ZOSTRICH GEOTECHNICAL

RE: REVIEW OF NANISIVIK MINE OPENINGS CLOSURE PLAN (JANUARY 27, 2005)

PROJECT: NANISIVIK ROCK MECHANICS REVIEW - III

PORTAL CLOSURE

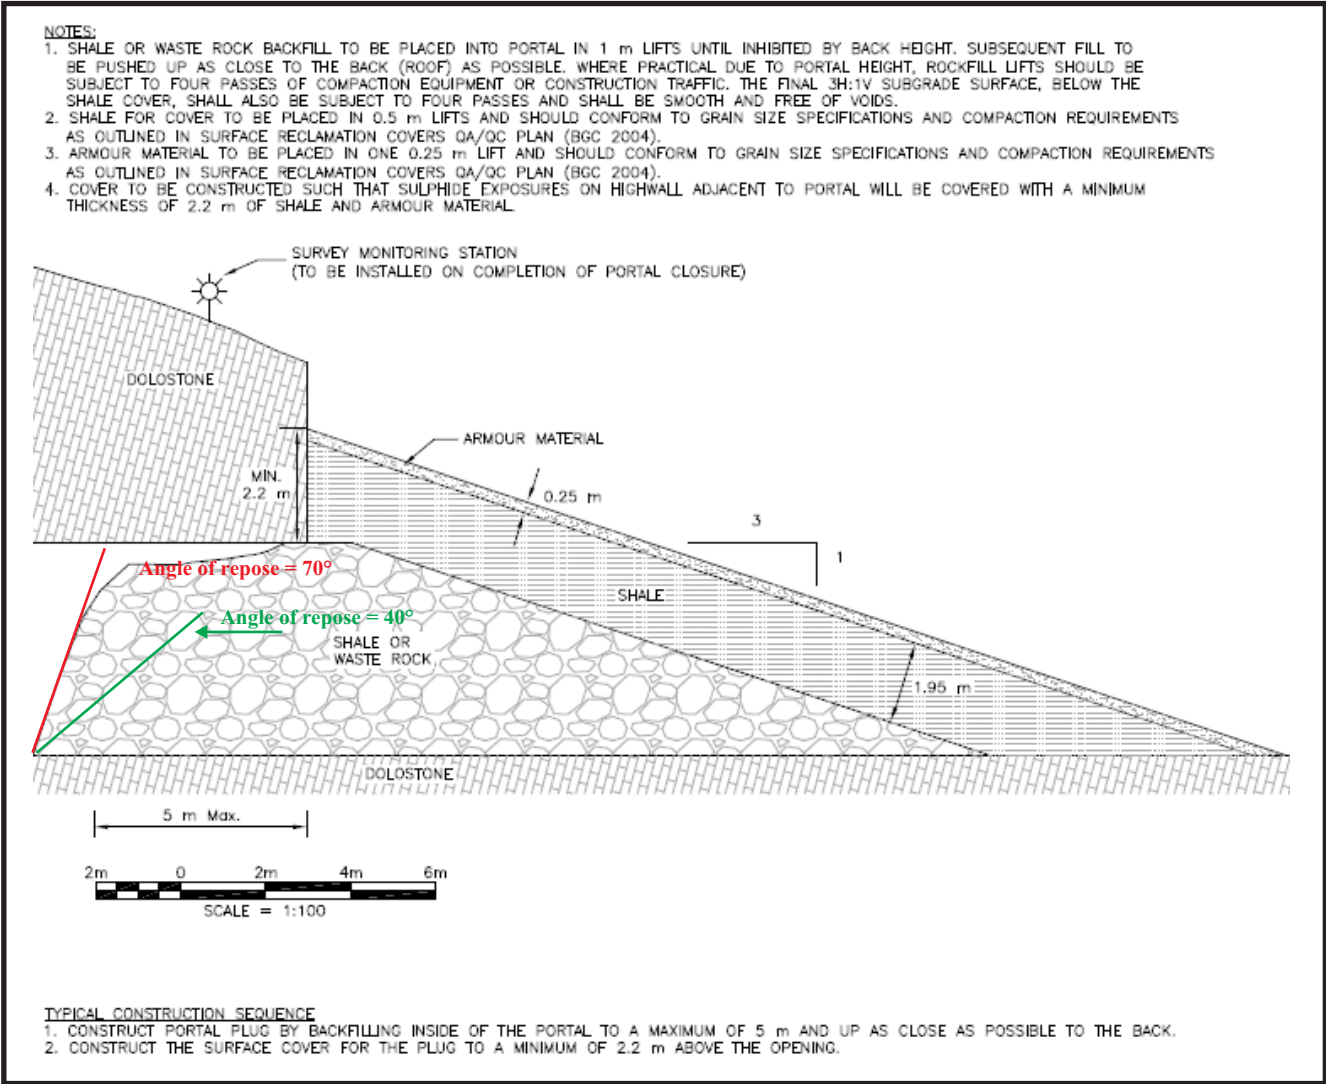
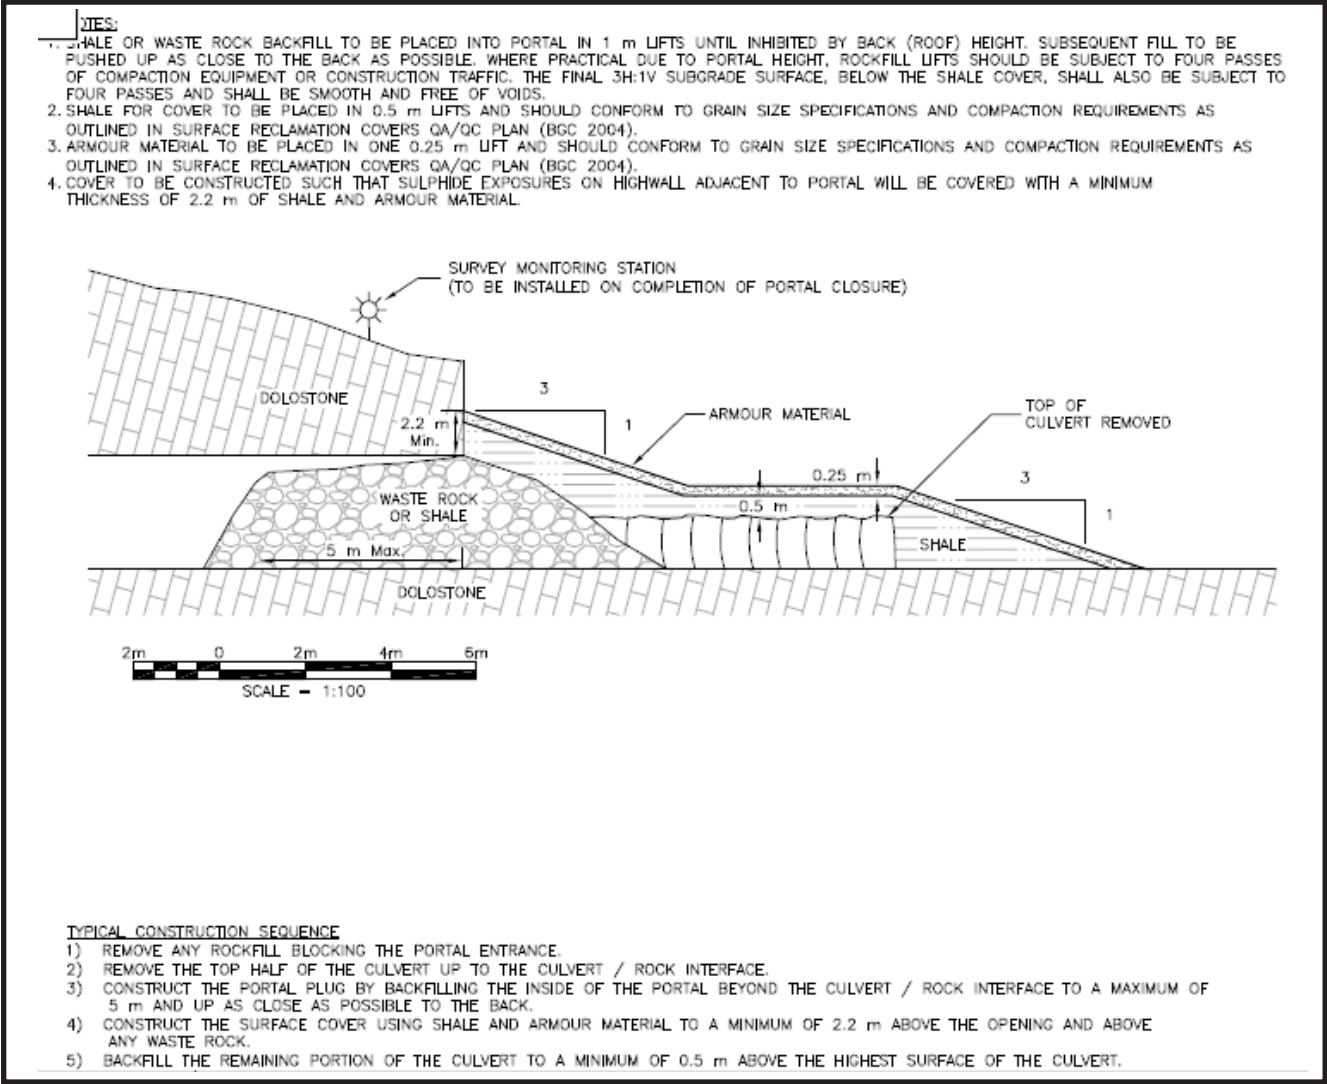
The portal reclamation schemes are generally found to be inadequate.

The backfill of the portal is incomplete. While the stated purpose of the backfill is to provide some support of the back, this is unlikely. As the fill is to be pushed into the portal a maximum of 5m, and not placed tight against the back, this will provide no, or at the very best, very limited support to the immediate portal area. Note that the angle of repose of blasted muck rarely exceeds 40°.

The rock capping the portal cap is insufficiently supported by adjacent fill or by underlying fill (or concrete) to be considered to be permanently remediated.

More detailed engineering work is required. This should include detailed sections of the portal, including specific structures as well as general rock fabric information, true ground profiles to such depth as failure is unlikely to breach surface, realistic engineered backfill options that demonstrably insure rock support to a depth where rock failure can be demonstrated to be unlikely to occur, and the effect of the present portal rock support (bolts, strap, etc.) degrading and being rendered ineffective over time.

Monitoring should be specifically designed for each portal such that it will take into account all of the above noted details. It should also be verified to function of the time period required for the aforementioned failure modes to manifest.
